ADDENDUM NO. 2

October 27, 2022

Carey Ridge Elementary Addition & Renovation
16231 Carey Road
Westfield, IN 46074

1 HEATING WATER P&ID
SCALE: NO SCALE

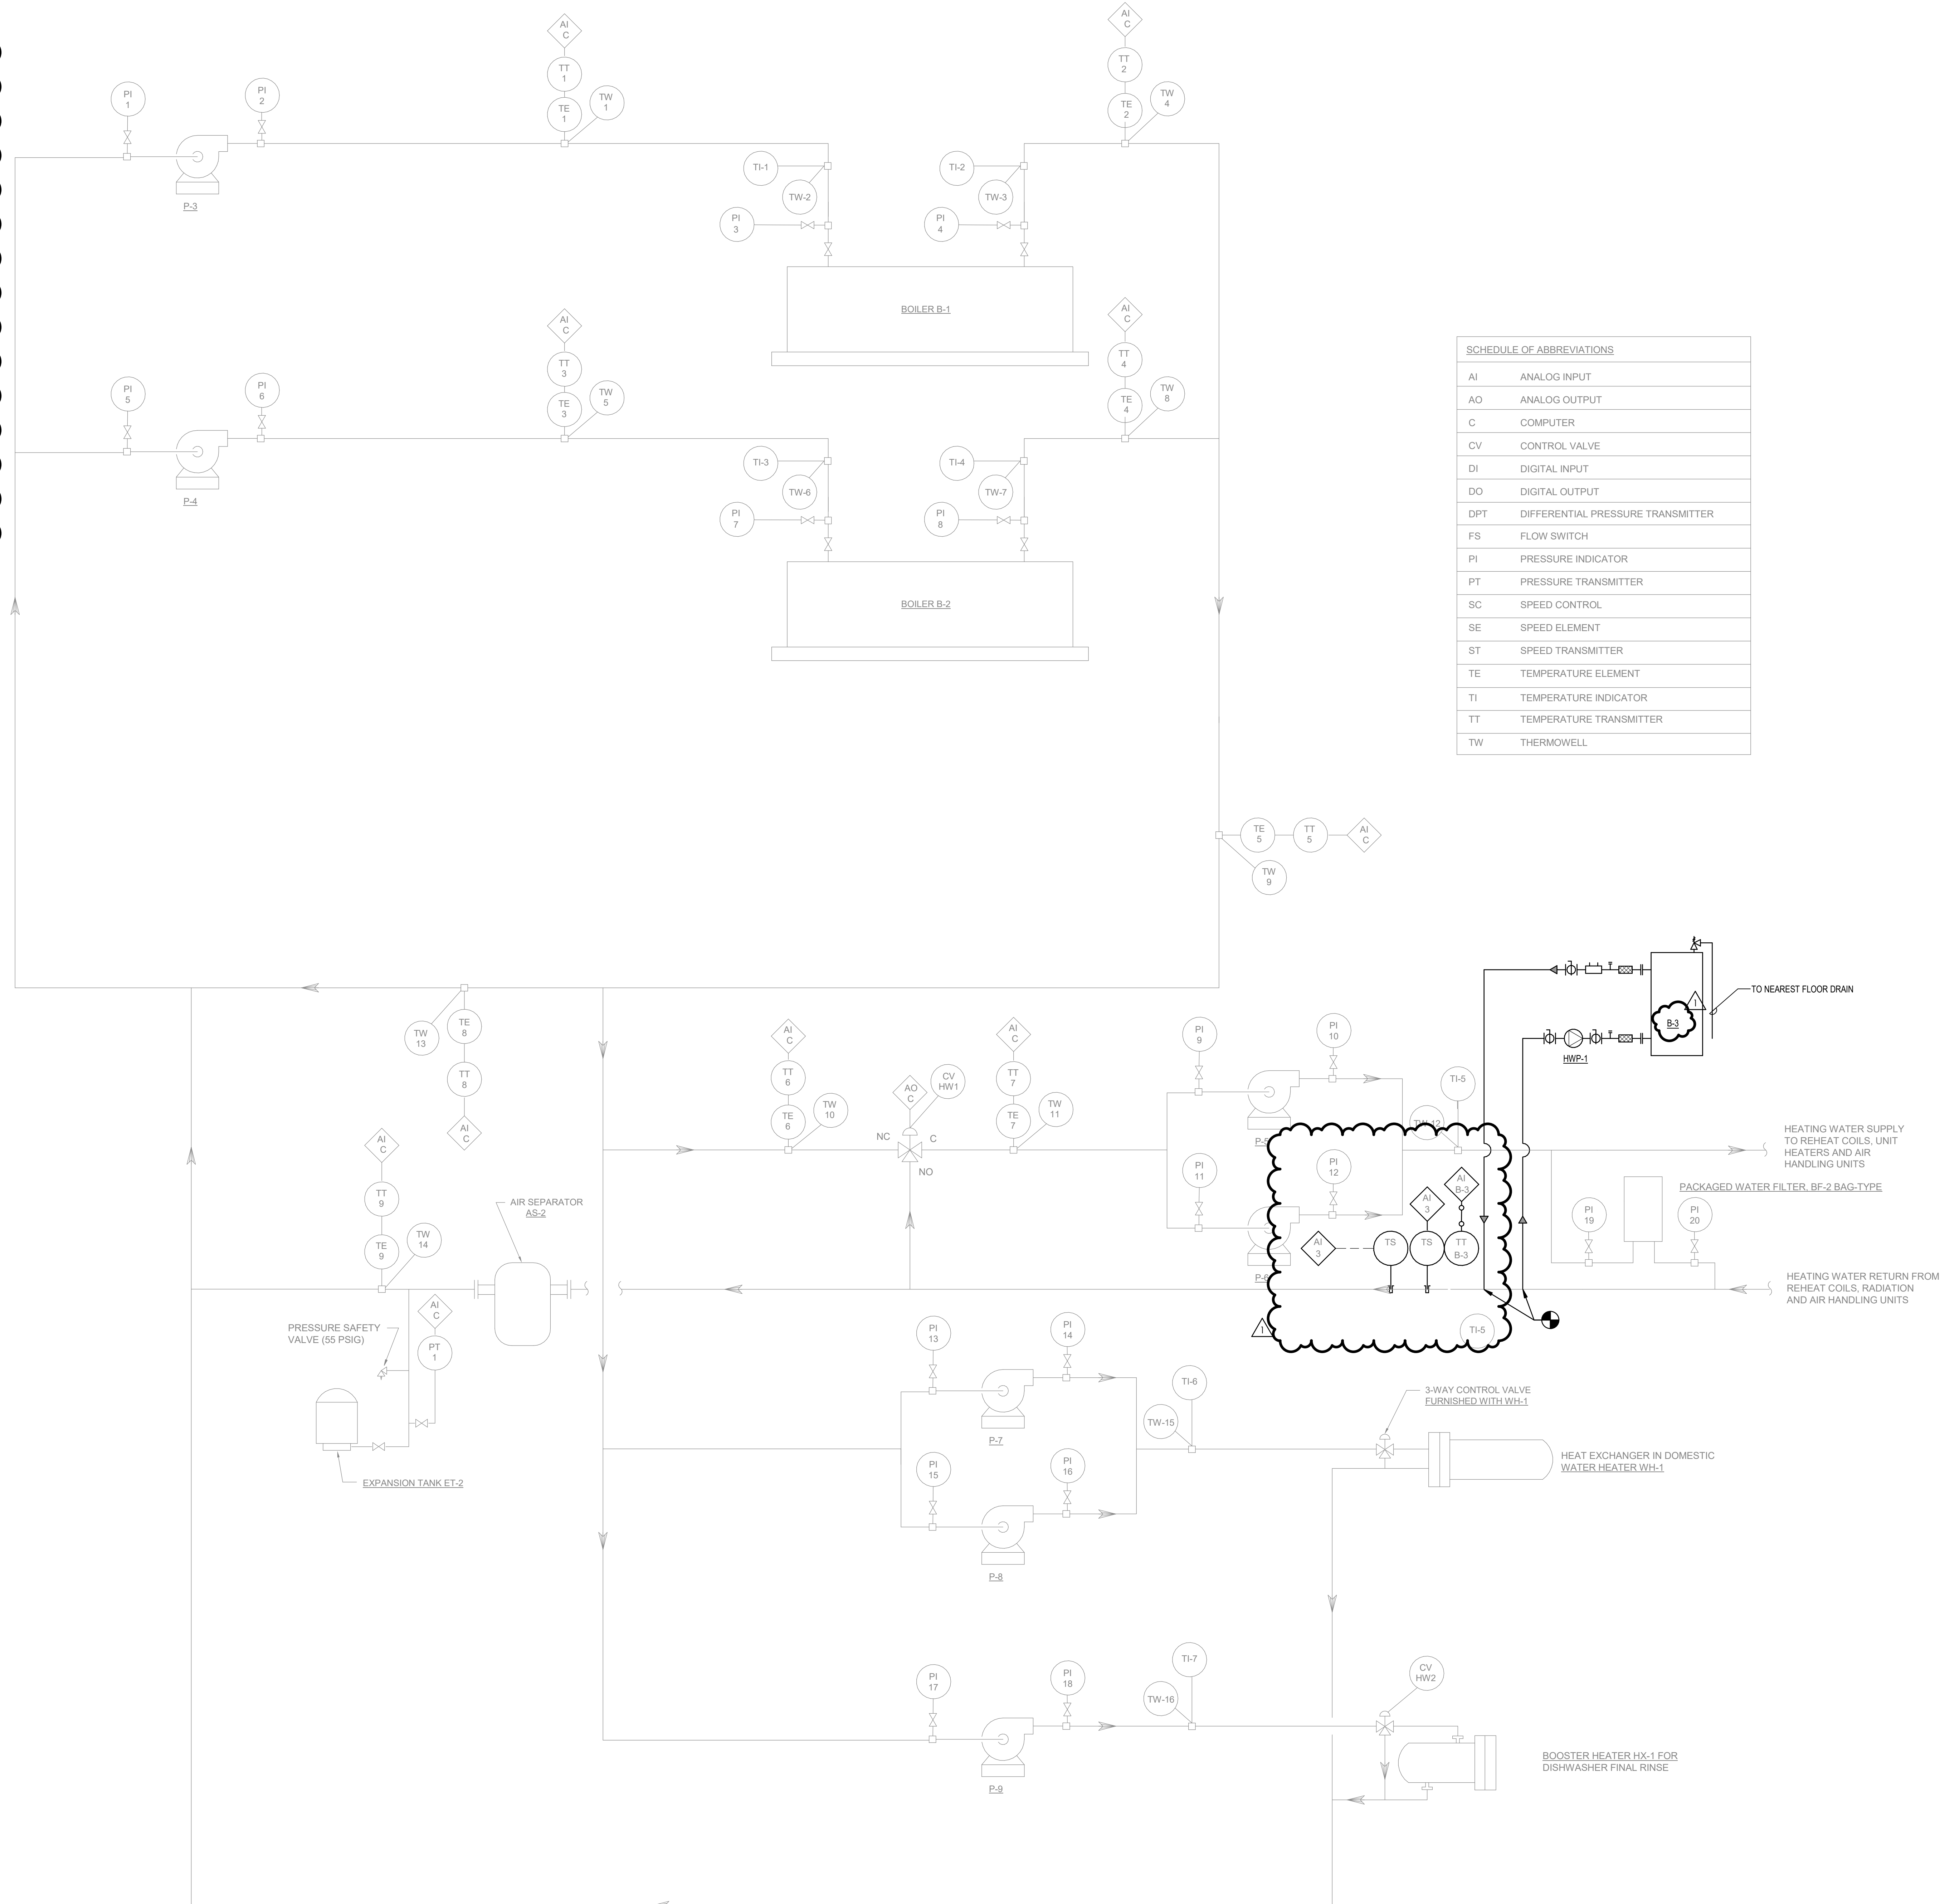
- A. Added sequence of controls. Refer to attached drawing.
